SAFETY EVALUATION BY THE OFFICE OF NUCLEAR REACTOR REGULATION

PRIMARY COLD LEG PIPING LEAK-BEFORE-BREAK REVISED ANALYSIS

NORTHEAST NUCLEAR ENERGY COMPANY

MILLSTONE NUCLEAR POWER STATION, UNIT NO. 2

Figure 1: Piping Layout of Millstone Unit 2 Main Coolant Loop

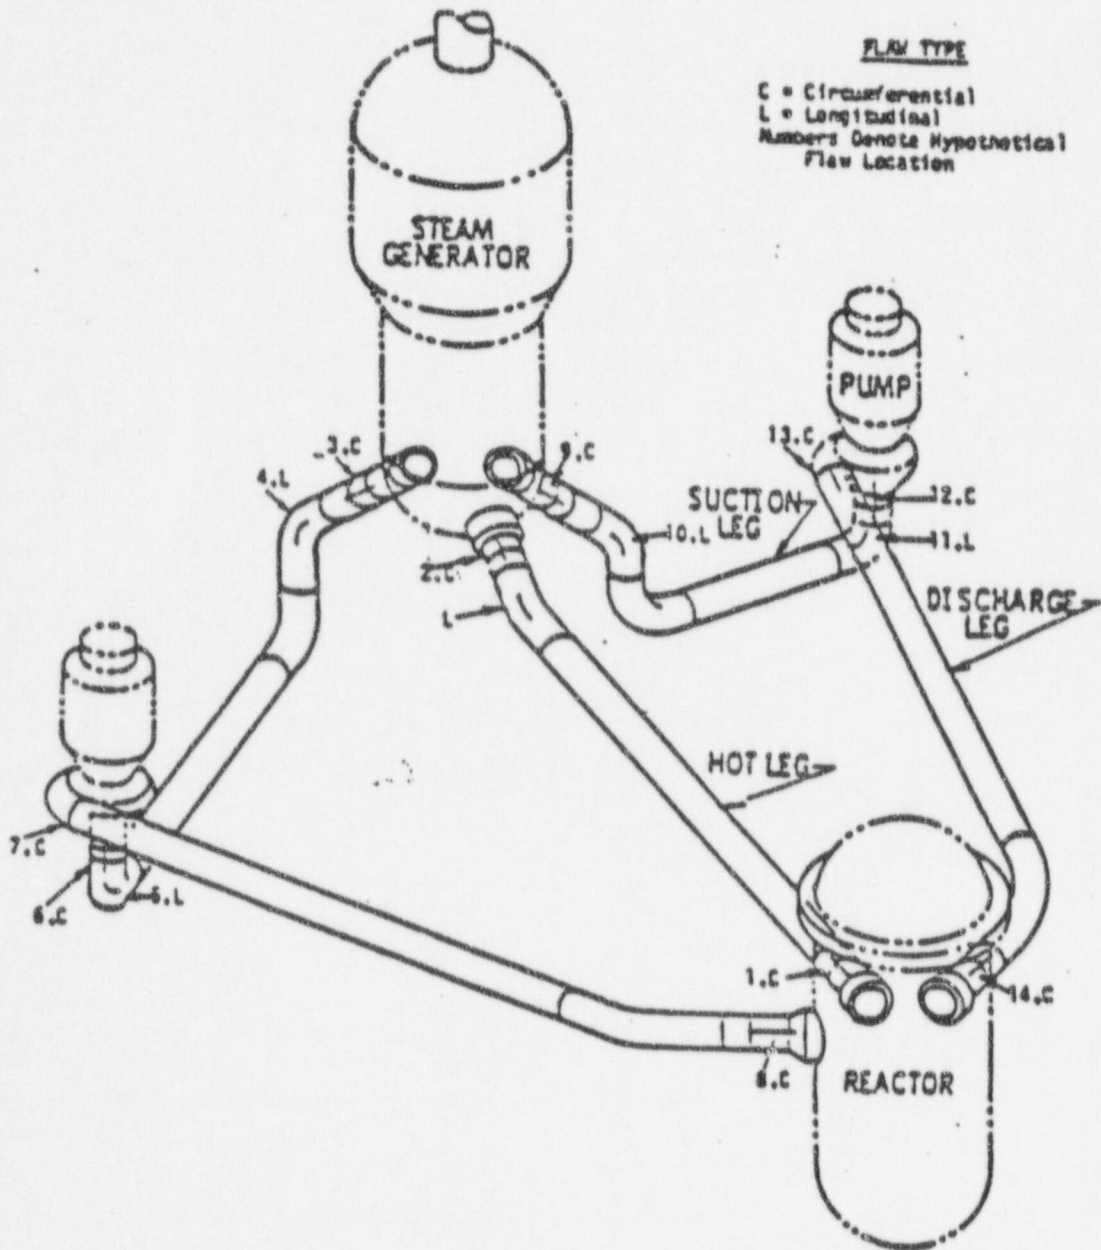
Based on the staff's evaluation of the loadings supplied by the licensee, the staff concluded that the limiting locations for the RCL piping evaluation would be location 6 (at suction nozzle of the RCP) or location 8 (at the piping connection to the RPV inlet nozzle) as shown in Figure 1. At location 6, the staff's evaluation considered the possibility of a crack in the CSS safe end between the ferritic piping and the RCP. At location 8, the staff's evaluation postulated a crack in the SA-516 Grade 70 weld between the cold leg piping and the RPV nozzle safe end.
